TECHNICAL BULLETIN

No. 206L-07-224

MODEL AFFECTED: 206L Series

SUBJECT: FAN ASSEMBLY, 206-040-370-ALL,
CONFIGURATION OF

Figure 1. Impeller

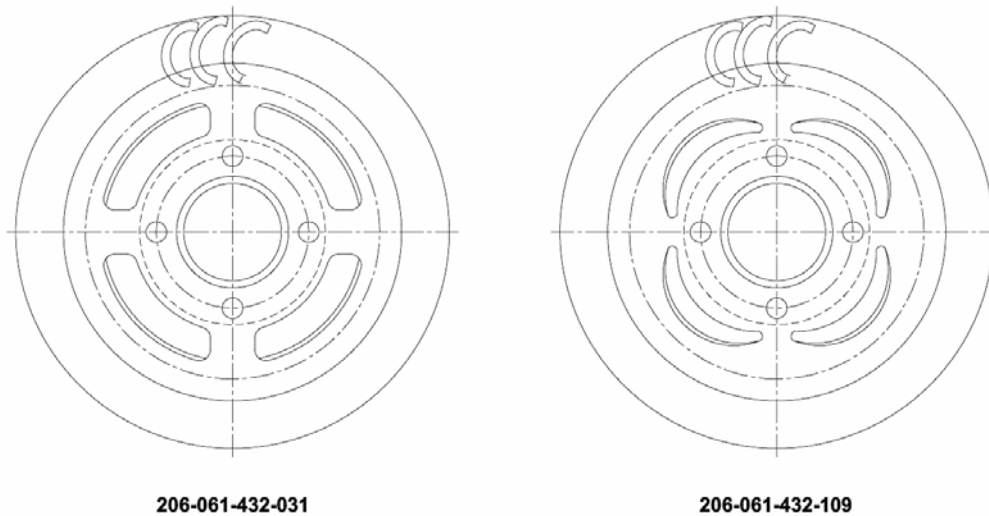
1. Replaced by blower assembly 206-061-432-033.
2. Replaced by blower assembly 206-061-432-107.
3. The -009 and the -029 housing are physically different. The opening of -009 for oil cooler adapter mounting is straight while this opening on the -029 housing is not symmetrical.
4. Replaced by impeller 206-061-432-031 (refer to ASB 206L-77-12).
5. Replaced by impeller 206-061-432-109 (refer to ASB 206L-86-40).
6. Figure 1 below provides with physical difference between impeller -031 and -109.
